<b>APPLICATION NUMBER:</b>	PLN-26-028
<b>PROPOSED DEVELOPMENT:</b>	Addition to existing multiple dwelling
<b>LOCATION:</b>	8A Chestnut Avenue Lutana
<b>APPLICANT:</b>	G O'Halloran
<b>ADVERTISING START DATE:</b>	18/04/2026
<b>ADVERTISING EXPIRY DATE:</b>	02/05/2026

**PLANNING APPLICATION – 8A CHESTNUT AVE, LUTANA**  
**DWELLING ALTERATIONS AND ADDITIONS; APPLICATION NO: PLN-26-028**

Further to your request for additional information regarding this application, we provide the following responses and the revised drawings Ap01.A to Ap05.A attached:

DESIGNED: DRAWN: CHECKED:  
SCALES: 1:100 AT A3 SIZE DRAWING SHEET  
PROJECT No. 25.257 DRAWING No. Ap04 REV. A

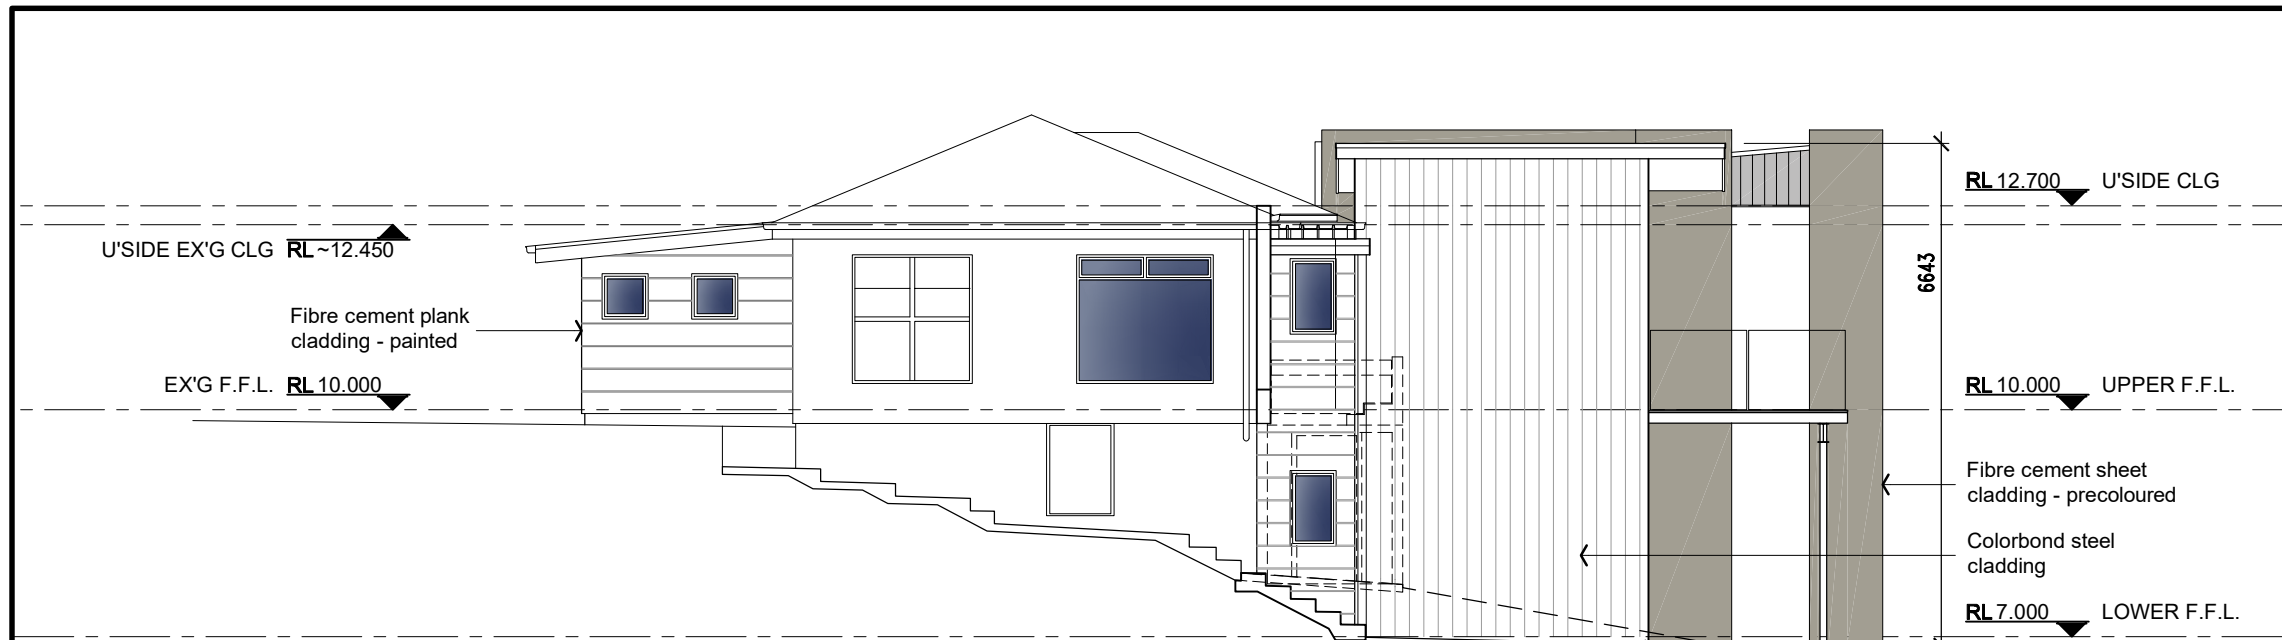
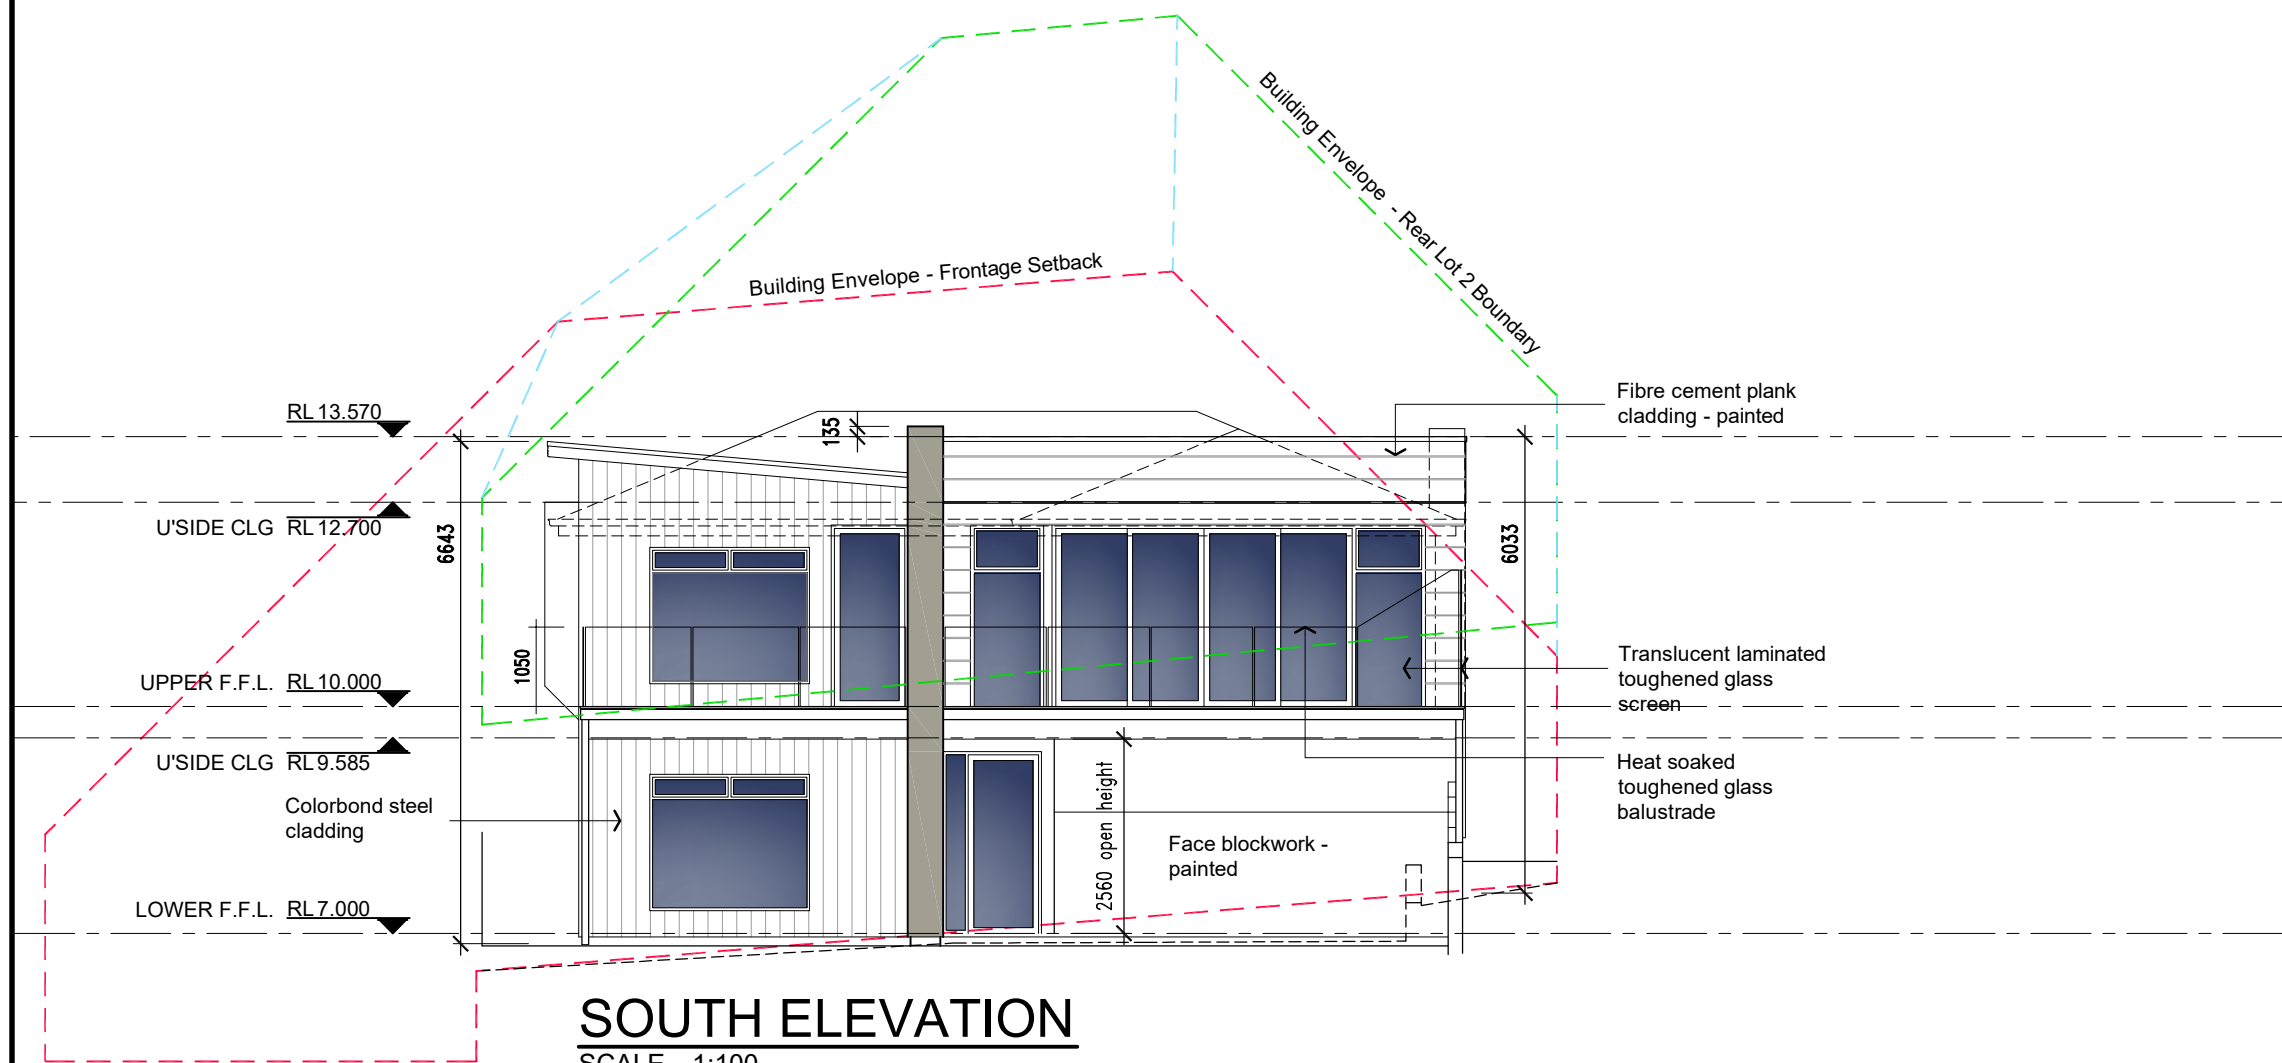
- 1. Please provide maximum height on plan*

- 6. Please show height above floor level for window on east elevation*

*Please demonstrate accordance with either the acceptable solution or the performance criteria. Screens must be labelled and shown on plan with material/transparency and height indicated.*

Refer elevation drawings Ap04.A and Ap05.A for requested height dimensions.

Refer elevation drawings Ap04.A for requested height dimension.

As described in the Planning Application the eastern side boundary is the only boundary impacted by this clause. Revised drawings Ap04.A and Ap05.A show a 1.8m high translucent laminated toughened glass screen at the east end of Deck 1 and a matching tapered height return screen panel adjacent.
